1991 Corvette: Service Bulletin: Squeak and Rattle Diagnosis Guide

Subject: SQUEAK AND RATTLE DIAG. GUIDE DIAGNOSTIC AID/CORRECTION

Model and Year: 1991 CORVETTE

Bulletin Number: 91-264-10 - (03/25/1991)

FIGURE 1

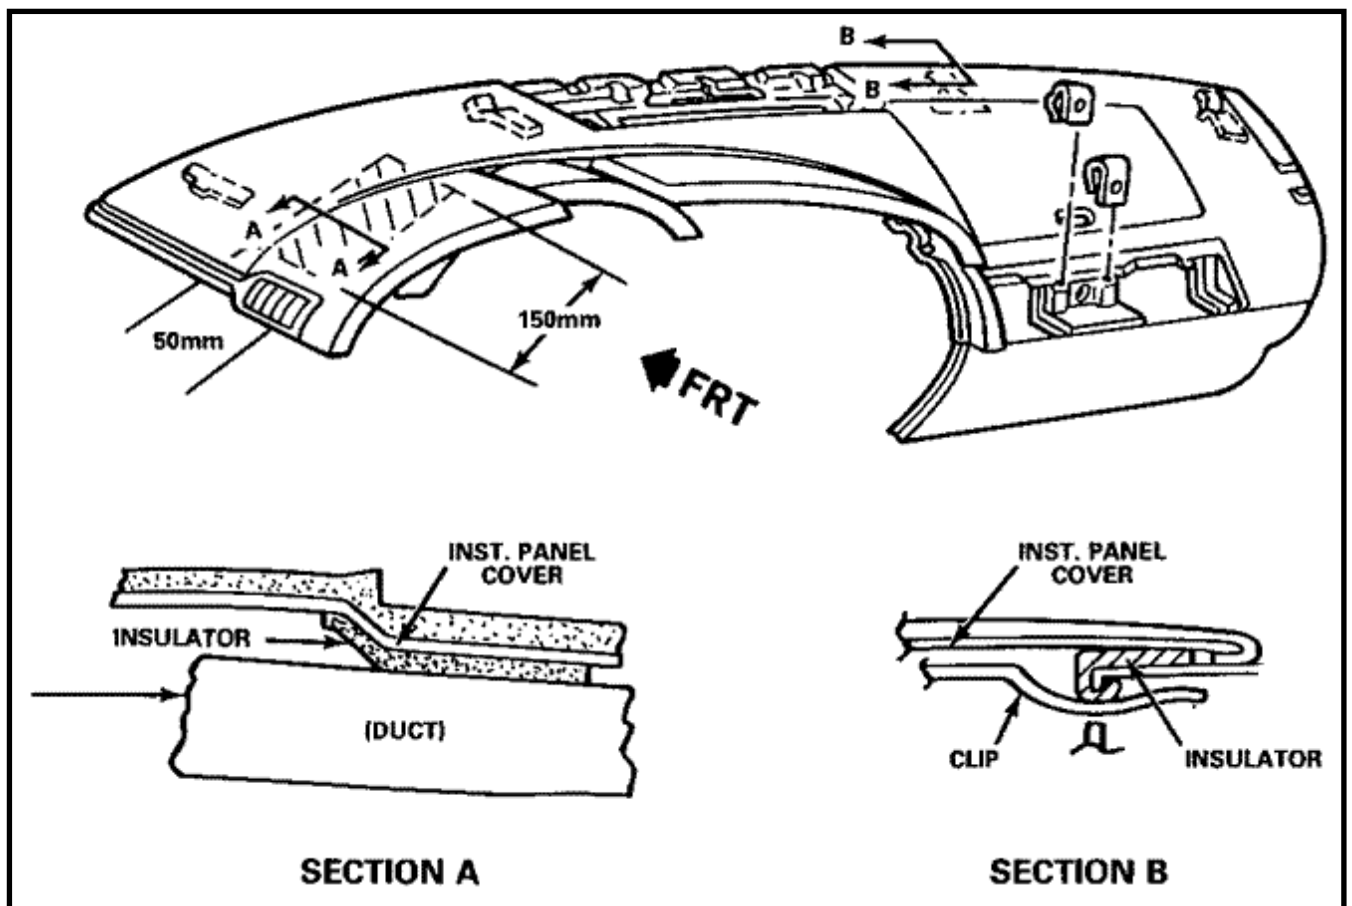
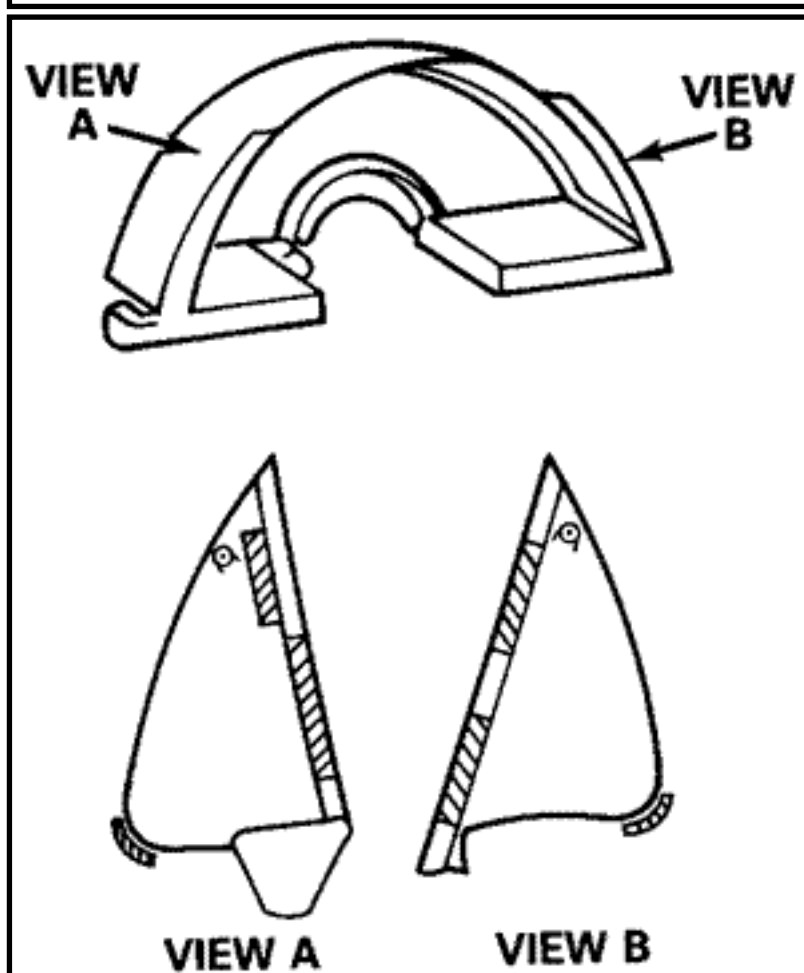
1. Rattle forward of gages cluster 1. Insulate area shown in Figure at A/C cross car duct. 1 and Figure 1, Section A (felt material).

2. Rattle at front edge of cover 2. Reposition existing, or near windshield. install felt insulators on metal opening at all retainers, (see Figure 1, Section B). - Left defogger outlet

FIGURE 3

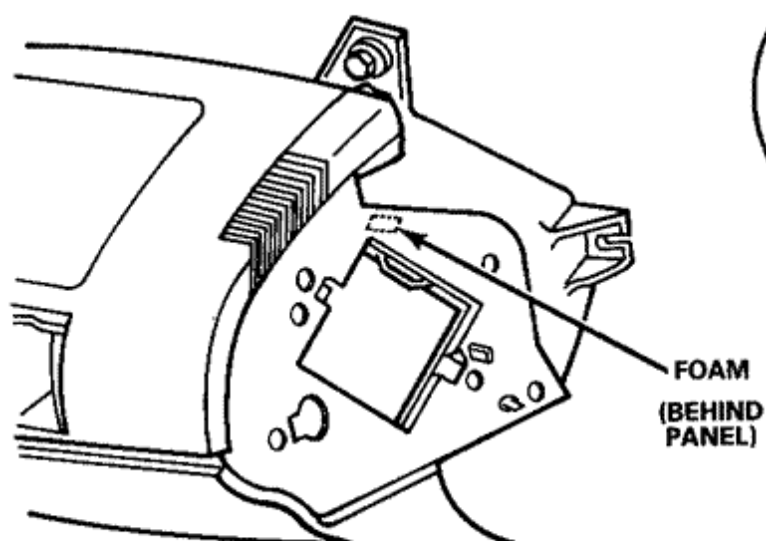
1. Squeak in instrument cluster 1. Apply felt insulators to bezel to cover. bezel edges and surfaces in locations as shown in Figure 3, views A and B.

FIGURE 5

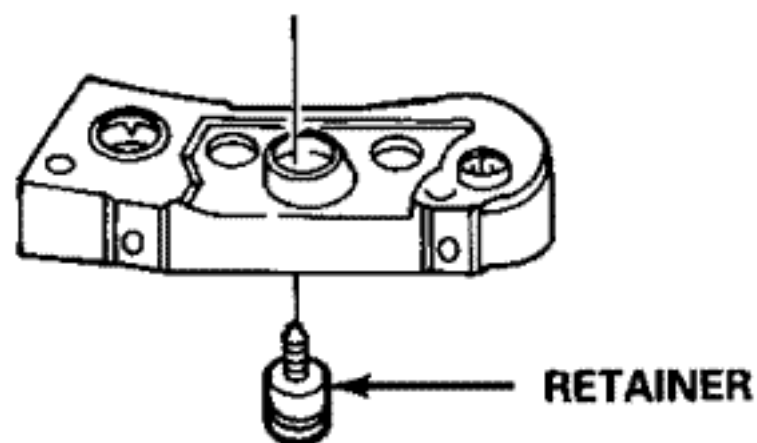
2. Buzzing of fuse box rivet 2. Apply small 1/4" foam heads to instrument panel insulator between rivet head cover. and cover as shown and cover as shown in Figure 5, view A.

3. Buzzing of fuse box door 3. Apply felt insulators (1/4" X in the opening. 1") as shown in Figure 5, view B. Position felt into the radius of the opening.

**REMOVABLE ROOF, FRONT
BOLT AND RETAINER**

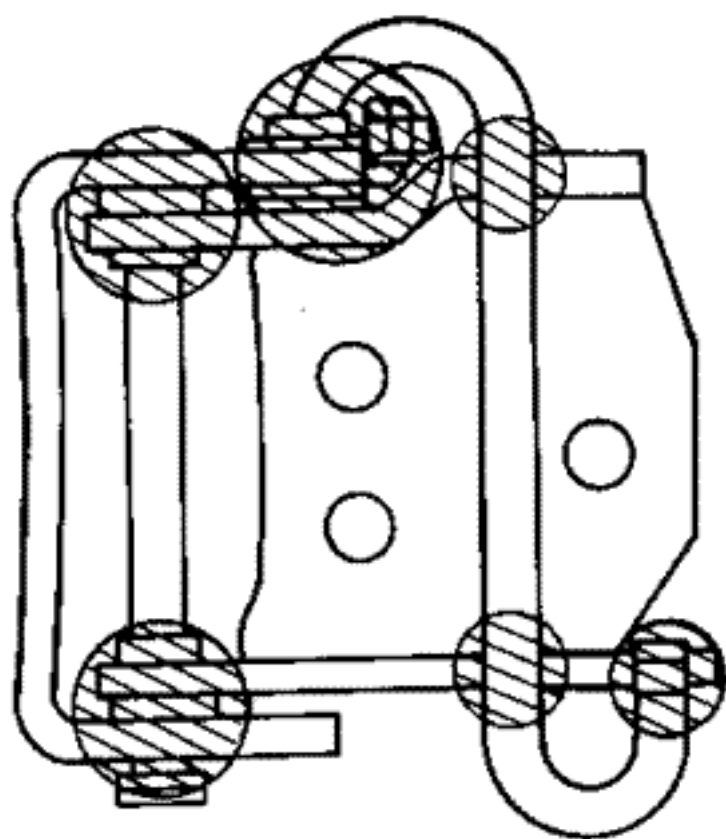
1. Rattle of front attaching bolts 1. Install new bolt retainers, when panel is stowed in rear. P/N 10 1 75804, see Figure 8.

1. Soak new retainers in warm water to aid in installation.
2. Remove roof panel and stow.
3. Remove upper trim covers at right and left latch areas.
4. Remove right and left sun visors, inside mirror and center garnish molding.
5. Carefully pry original retainer and bolt out of housing using a flat blade screwdriver or other suitable tool.
6. Install bolt in new retainer, align locating rib on retainer with notch in housing and press into place with a "C" clamp and socket.
7. Reinstall garnish molding, inside mirror, sun visors and upper trim covers.

LUBE AT SHADED AREAS
DOOR UPPER HINGE

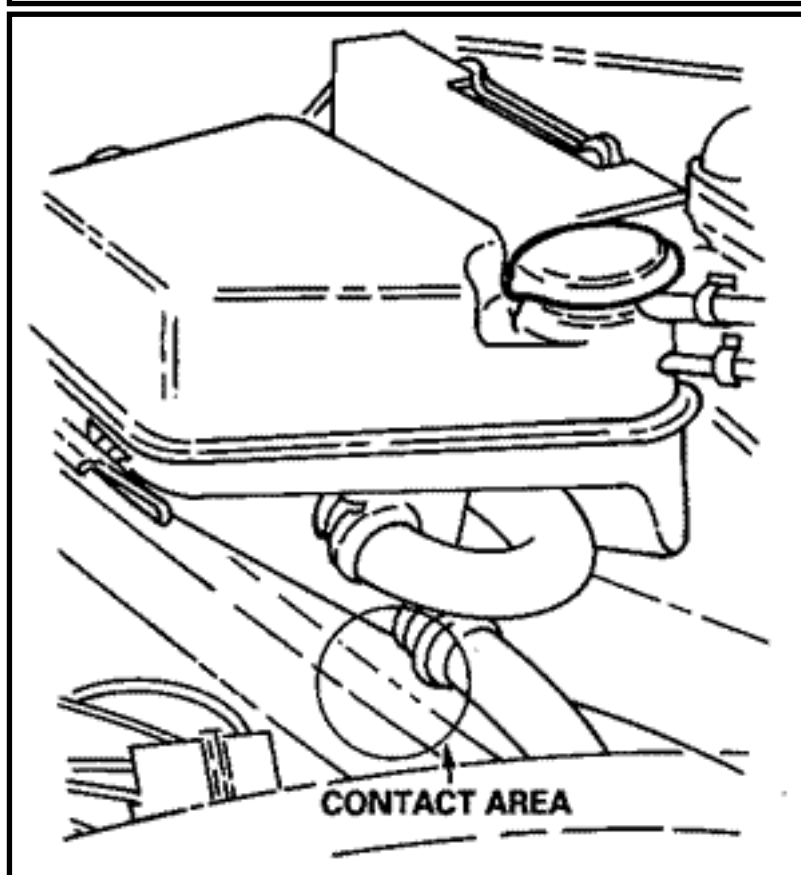
1. Squeaks when opening doors at 1. Lubricate ALL hinge torque hinge torque rod contact areas. rod contact areas with 30 wt. motor oil or grease, see Figure 9. UNDER THE HOOD ----- COMPONENT
